Advisory Committee For Hirakund Dam Project 1948

We are submitting herein our report on the Hirakud Dam Project, the first of the works in the plan for unified development of the Mahanadi Valley, Orissa Province. The site was inspected by Dr. Savage in March 1947 and by Messrs. Narasimhaiya and Gadkary in April 1948. We have examined the data placed before us and our report is based on it.

SUMMARY OF RECOMMENDATIONS.

MASS CURVES FOR INFLOW AND OUTFLOW FOR A 10,000 YEAR FLOOD OF 1205000 CUSECS PEAK INFLOW INTO HIRAKUD RESERVOIR

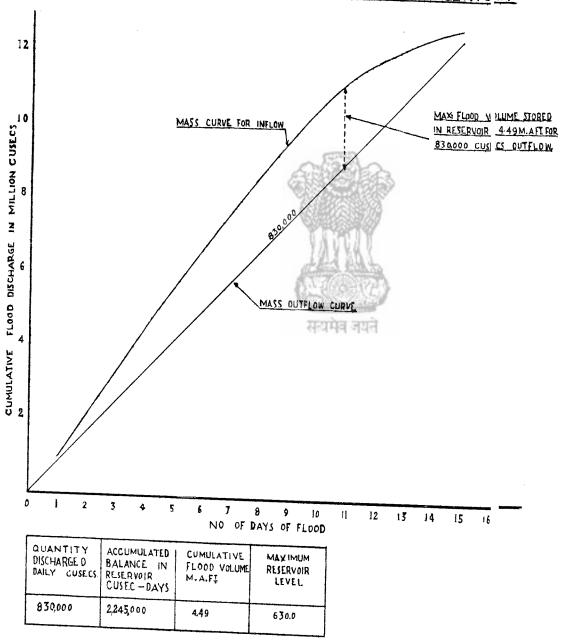
In the case of a 1,000 year flood the reservoir level can be allowed to rise to R. L. 630.0 with a corresponding gauge of 90.3 at Naraj. For the 10,000 year flood with a reservoir level of 630.0, the Naraj gauge will rise to 90.8. A gauge of 90.3 at Naraj will be only slightly above the safe gauge of 90.1 and can be accepted without hesitation for a 1,000 year flood. A gauge of 90.8 will be on the danger side but the probability is once in 10,000 years and this risk will be permissible. It must, however, be pointed out that with the regulated flow secured by the construction of the Hirakud Dam, the channel regime will improve and a lower gauge reading at Naraj can be reasonably expected so that the possibility of serious damage becomes remote.

MASS CURVES FOR INFLOW AND OUTFLOW FOR THE HIRAKUD RESERVOIR FOR A 100 YEAR FLOOD OF 1110000 CUSECS PEAK INFLOW

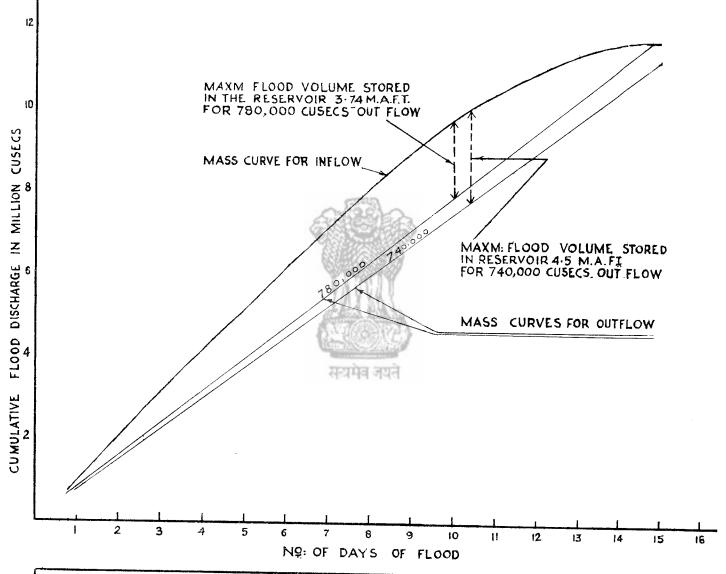
In the case of a 100 year flood, a reservoir level of 625.0 will give a corresponding gauge of 90.2 at Naraj which is slightly above 90.1 the assumed safe gauge. We consider that R. L. 625.0 should be taken as the normal reservoir level. Lands coming under submersion should be acquired to this level.

FIG 1

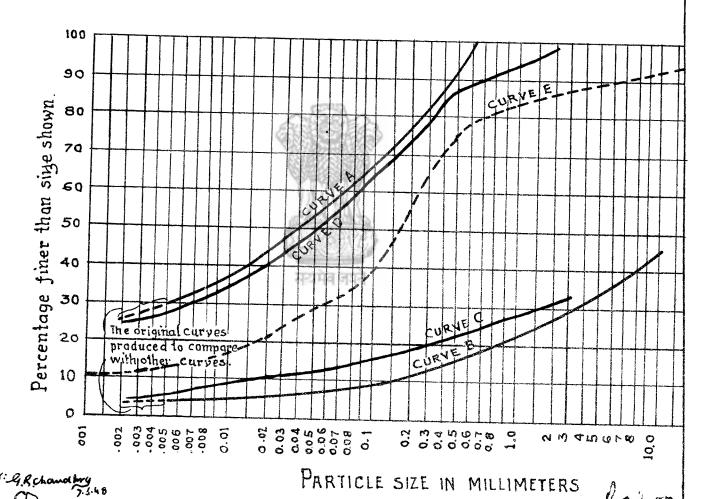
(a) Impervious section.—For soils suitable for use in the construction of the impervious section of the dam, C.H. Lee of the State Rivers and Water Supply Commission Victoria, has specified two limiting curves [fig. 1 (A) & (B)] and it is desirable that the grading of the soil for use in the impervious section should lie between those two curves and approximate to their general slope (as Curve E Fig. 1). The curves for two of our typical soils, one of each of the two classes of soils mentioned above are also plotted in the same Figure [marked (C) & (D)]. It is clear from the proximity of the curves (C) & (D) to curves (A) & (B) that
